Sea-Tac Runway Fill Hydrologic Studies

Mid-Study Fact Sheet—Volume 1, Number 2, March 2000

Figure 1

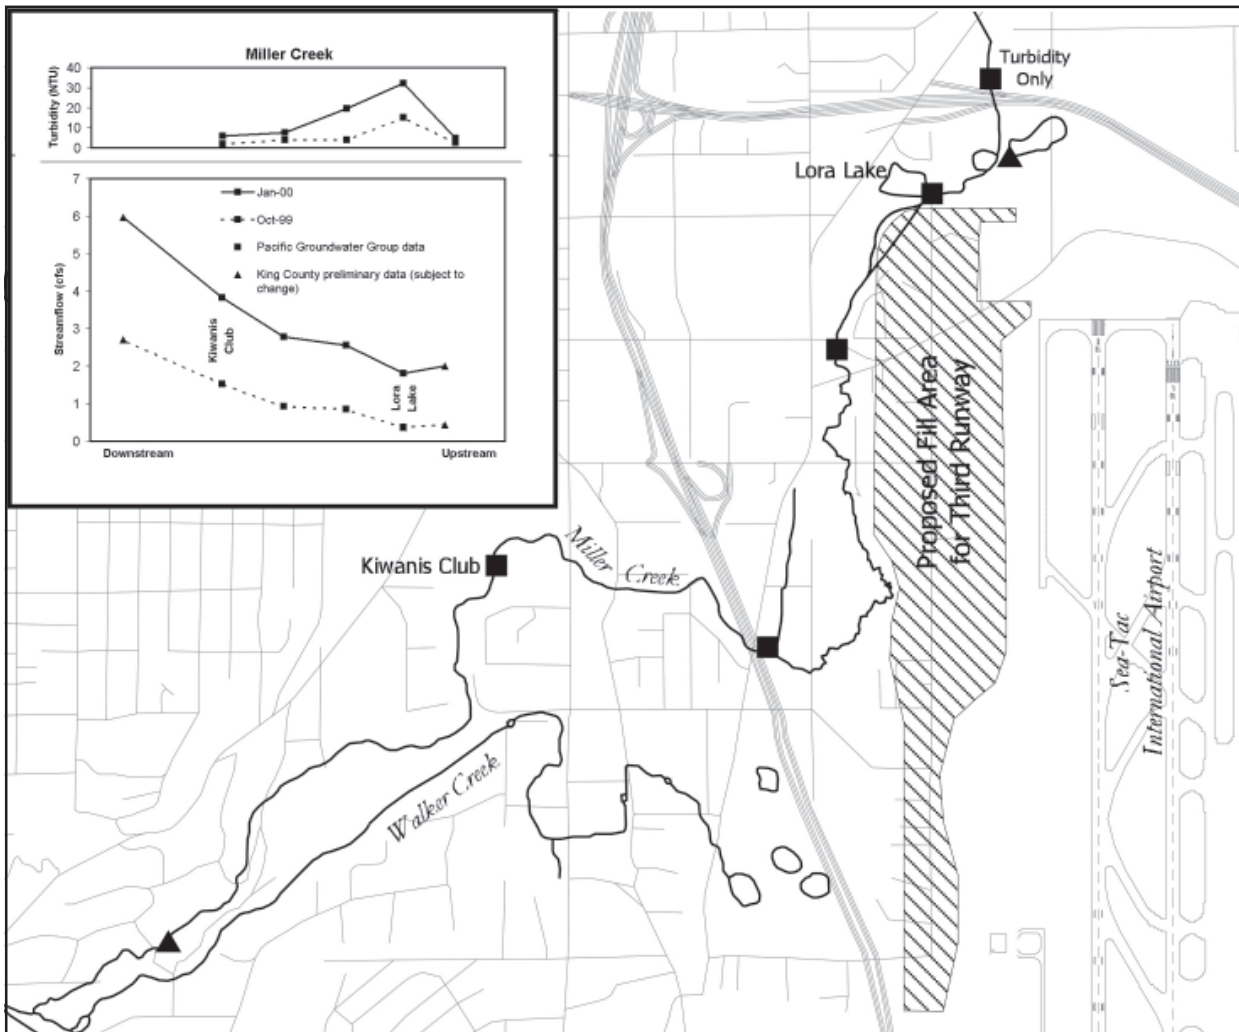
Project team consultant PGG measured stream flows at several locations in Miller, Walker, and Des Moines Creeks during dry periods in October, November, and January. Figure 1 (on page 3) shows the fall and winter streamflow measurements for Miller Creek. The measurements indicate that flow increases downstream at both times of year. However, the flow rate varies depending on the season. At every measurement station along Miller Creek, flows were substantially higher in January than in October. Between Lora Lake and South 156th Street, and between SR-509 and the Kiwanis Club, flow increases substantially in the absence of surface water contributions, indicating groundwater flow to the creek. About half of the increase at the Kiwanis Club appears to be water from the Miller Creek Detention Facility. The other half comes from shallow groundwater flow to the stream in the project area.

The water quality in Miller, Walker, and Des Moines Creeks was analyzed for a wide range of parameters that help define the environmental health of a creek. Surface water quality parameters, including oxygen, temperature, and *turbidity*, were measured at every streamflow station in the field. Figure 1 summarizes the turbidity measurements for Miller Creek. For both rounds of measurements, turbidity was highest just downstream of the Miller Creek Detention Facility (labeled as “Lora Lake” on Figure 1) and improved downstream. Groundwater and wetland water are typically very low in turbidity; therefore, Miller Creek turbidity improves as groundwater and wetland water flow into the creek downstream of the detention facility.
